## Elkhart County Community Corrections

201 N. Cottage Avenue  
Goshen, Indiana 46526

Location		Structural Inconsistencies		Recommended Corrections/Modifications to Provide Access	Technical Information			Finalized Actions		
Location	Photo	Identified Issue	ADAAG Specification		Priority Ranking and Justification	Improvement Cost	Funding Source	Finalized Correction	Anticipated Date of Completion	Date of Completion

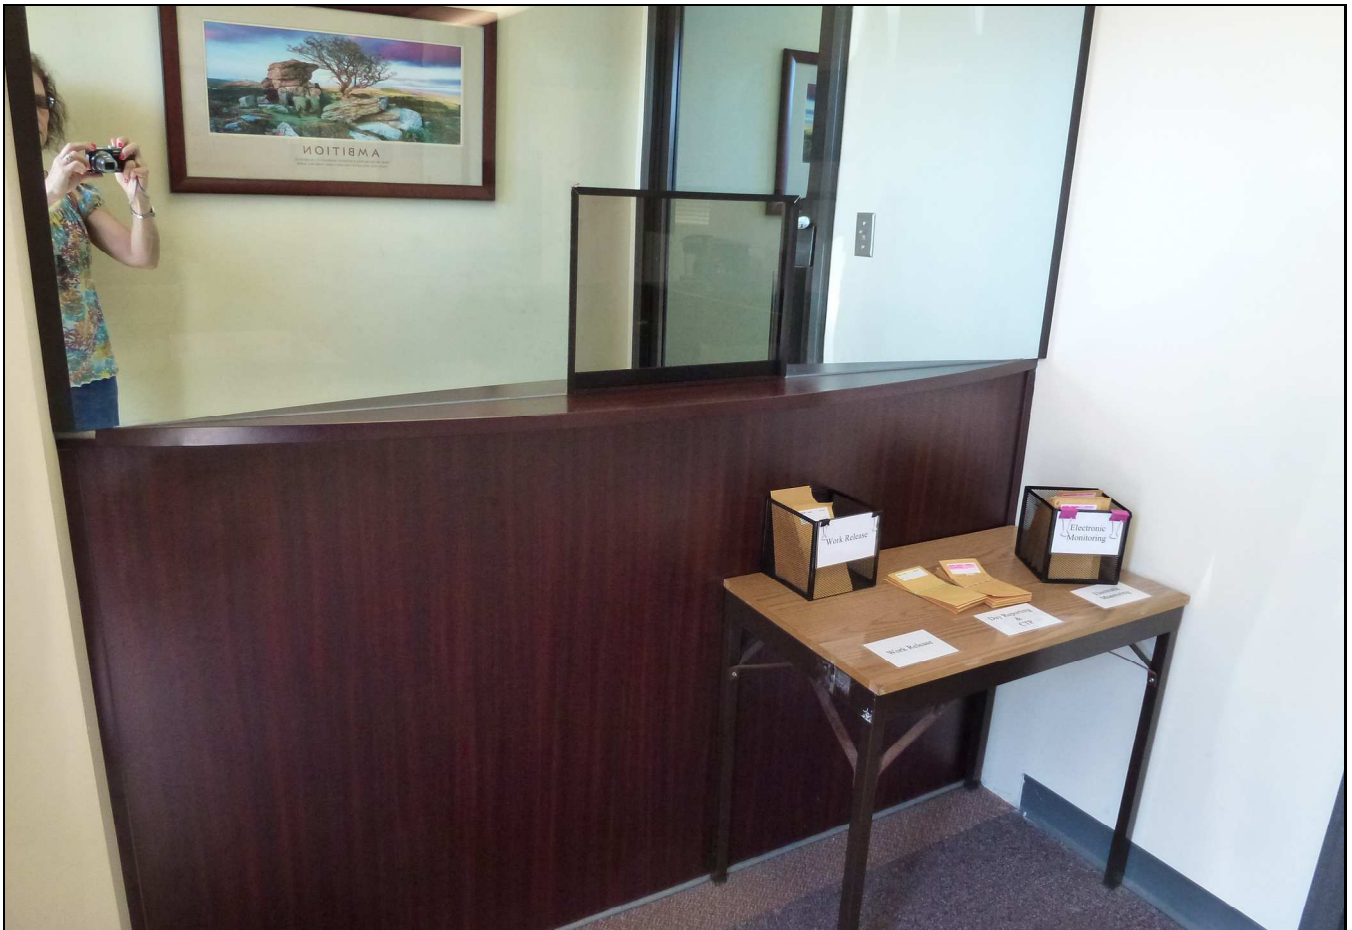
1. Parking	1,2	Adequate number of parking spaces are not available.	4.6.1	ADAAG requires parking spaces required to be accessible by 4.1 shall comply with 4.6.2 through 4.6.5. <b>Area needs 4 spaces.</b>	<b>H:</b> Accessible spaces need to be provided.	\$2,000	Elkhart County General Fund	<b>Parking striped</b>		<b>Aug-14</b>

2. Counters	3	Portion of main counter exceeds maximum height of 36 inches. Could walk through a door and come around.	7.2	ADAAG requires a portion of the main counter which is a minimum of 36 inches in length shall be provided with a maximum height of of 36 inches. <b>Provide a lower auxiliary counter or folding shelf. Arrange the counter and surrounding furnishings to create a space to hand items back and forth.</b>	<b>H:</b> Everyone must use this counter. No room to walk around.	\$2,500	Elkhart County General Fund	<b>Remodeled</b>		<b>Jul-18</b>
